## Planning Commission Vote Report

**Subject:** Change of Zoning Vote Report

**Petition:** **P.Z. 06-2015 17505 Chesterfield Airport Road (AutoZone)**

# PRELIMINARY PLAN

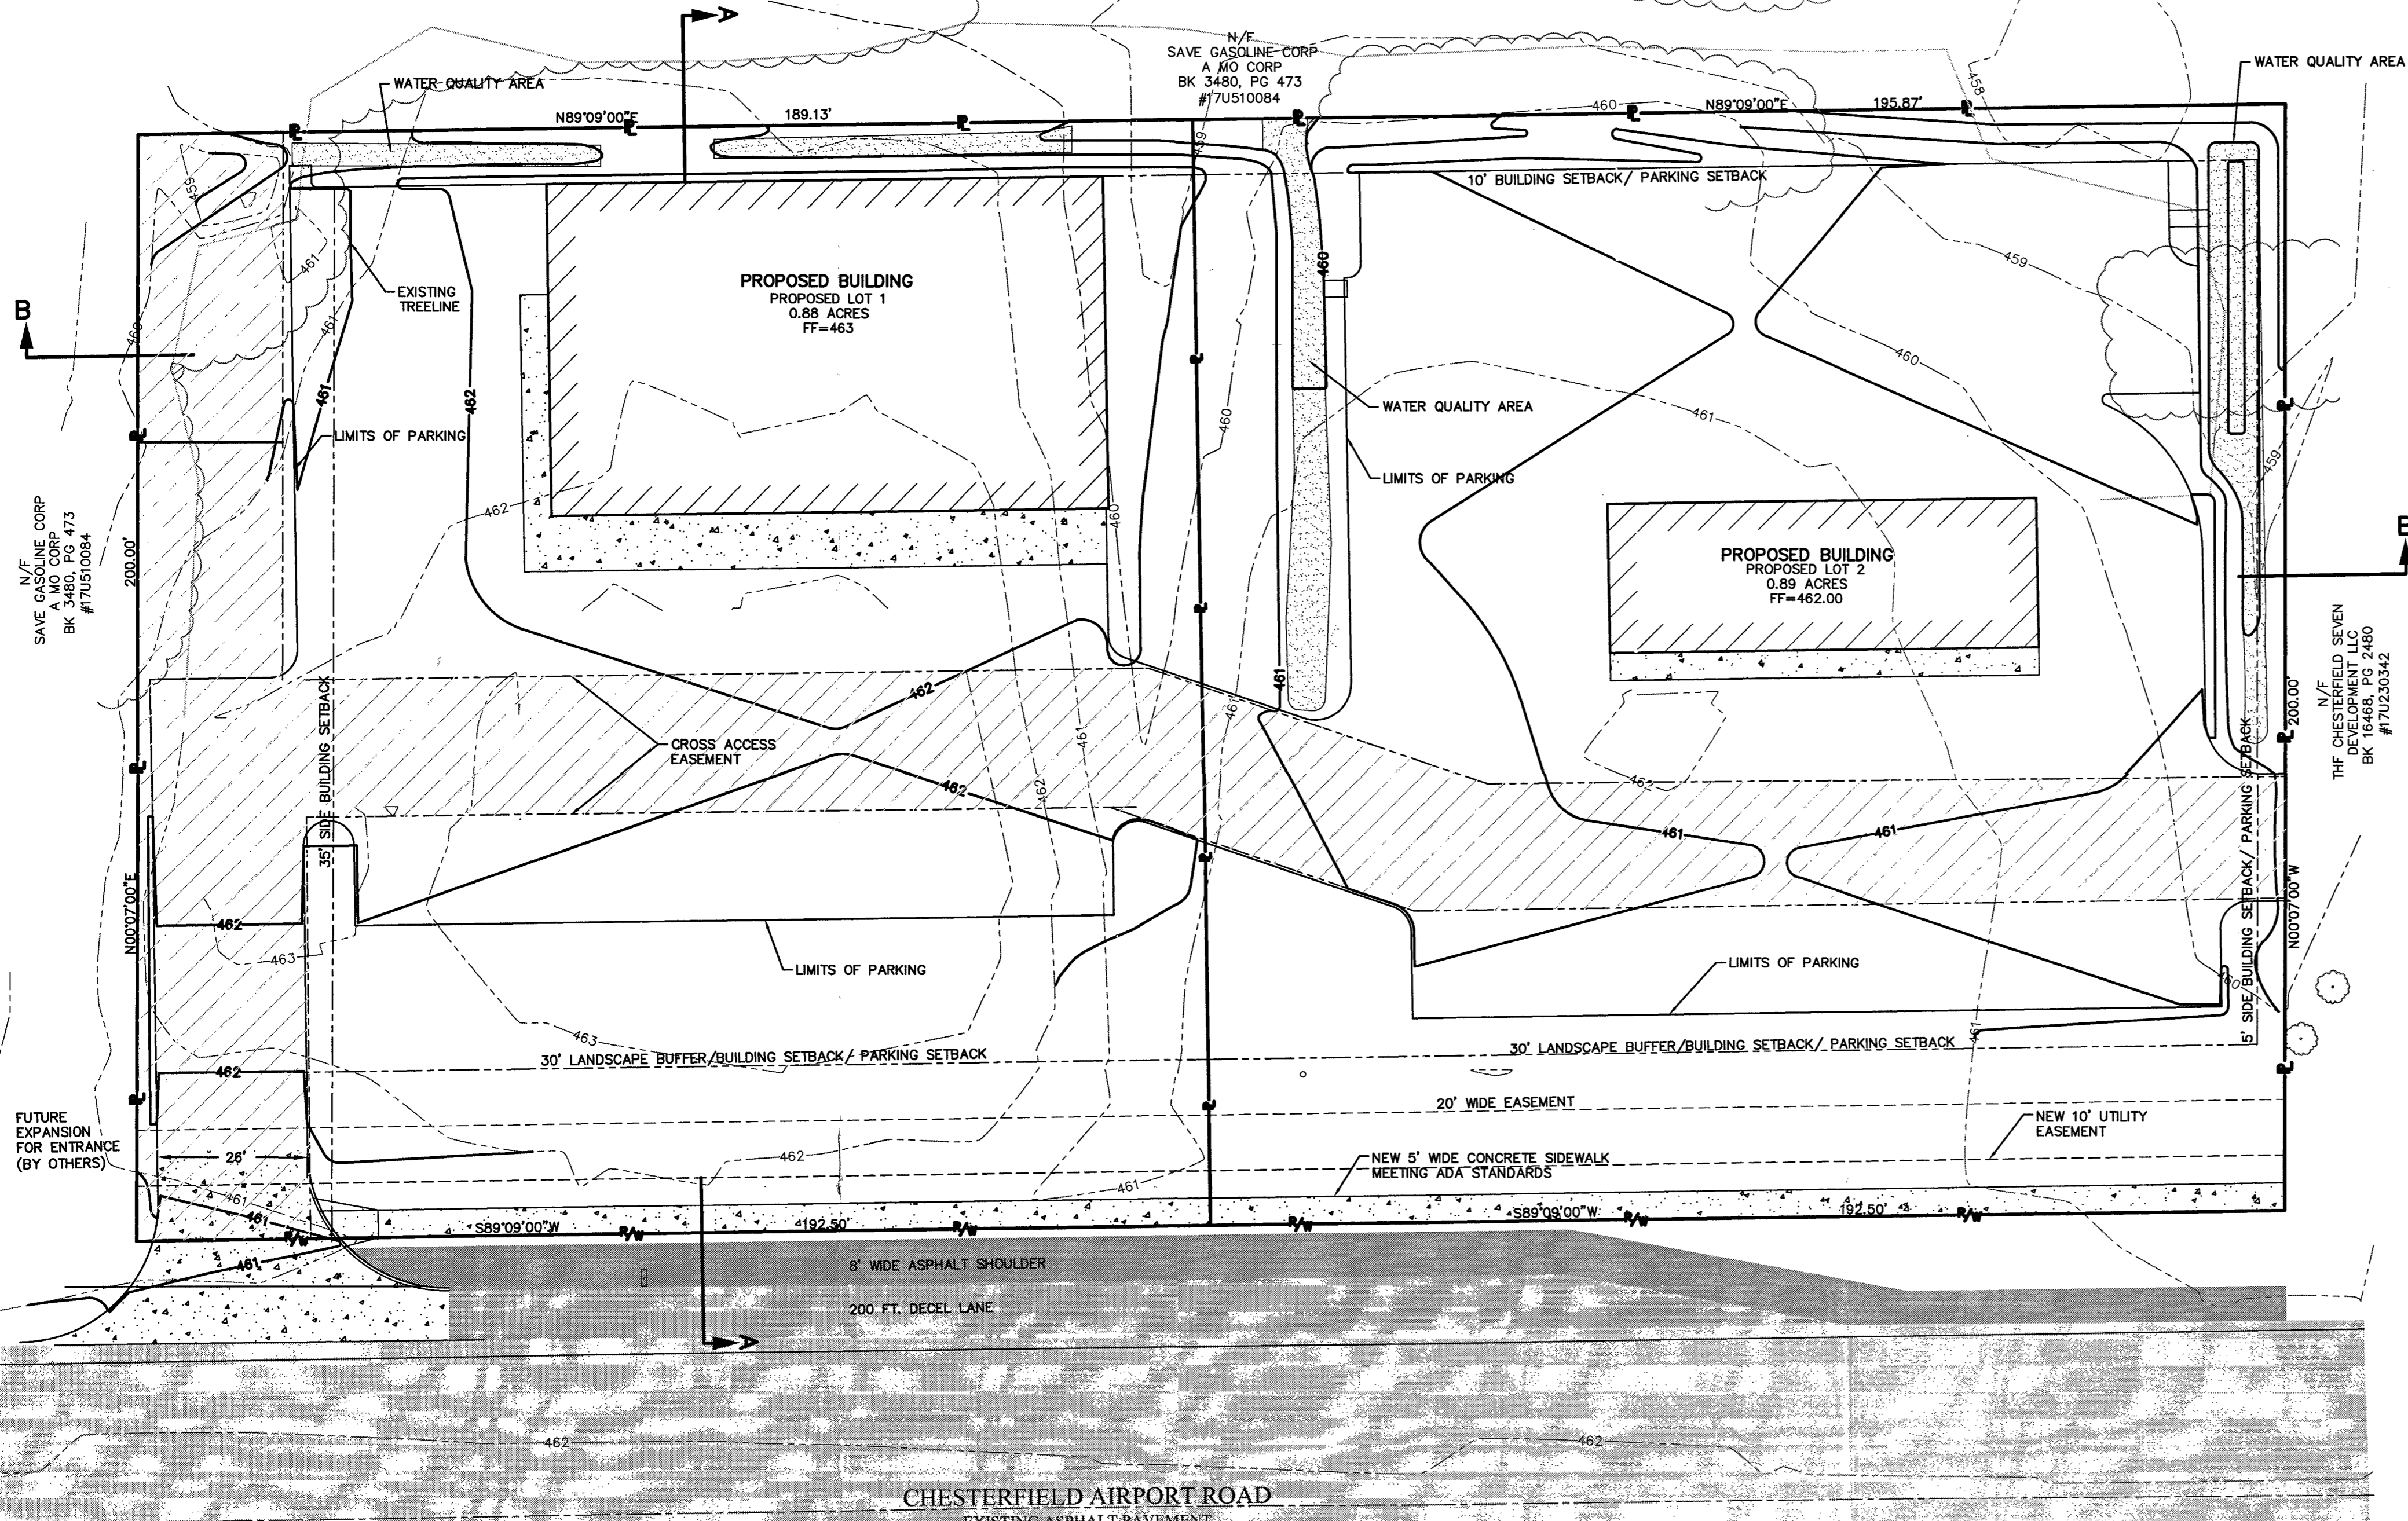
- 1. The Preliminary Plan as presented did not provide for adequate site circulation for the requested drive-thru uses.**

- 2. Due the location and layout of the access from Chesterfield Airport Road and internal shared drive, which will be expanded to a shared access point as future development occurs around this site, revisions to the setbacks, location of open space, and cross-access easements as shown on the Preliminary Plan were required.**

The Petitioner submitted a revised Preliminary Plan to show a centered building on proposed Lot 2 that renders the drive-thru use component of several of the requested permitted uses feasible. The centered building would permit for the adequate vehicular circulation associated with a drive-thru use component; however, the precise layout and configuration of such a use would be fully reviewed during the Site Development Plan review phase. Staff has reviewed the plan and found it to be in compliance with the requirements of the City of Chesterfield Unified Development Code.

The Petitioner revised the Preliminary Plan and the access has been aligned with the existing Valley Center Drive on the south side of Chesterfield Road. The access as shown on the Preliminary Plan will be expanded in the future to serve the adjacent parcel as it develops and will eventually tie into the westward Arnage Road extension.

The cross-access easement configuration was revised to allow for east-west access across the two proposed lots as well as access to the adjacent northern property that aligns with the entrance access from Chesterfield Airport Road. The northern cross-access easement that was previously proposed between the buildings was eliminated, providing additional space on the site for the provision of open space, stormwater quality features, parking, etc. which will be reviewed in detail on a future Site Development Plan submittal. Accordingly, the parking setback between the proposed Lot1 and Lot 2 was eliminated and a greater building setback from the western boundary of proposed Lot 1 was added to the plan to accommodate the site entrance access and northern cross-access easement.
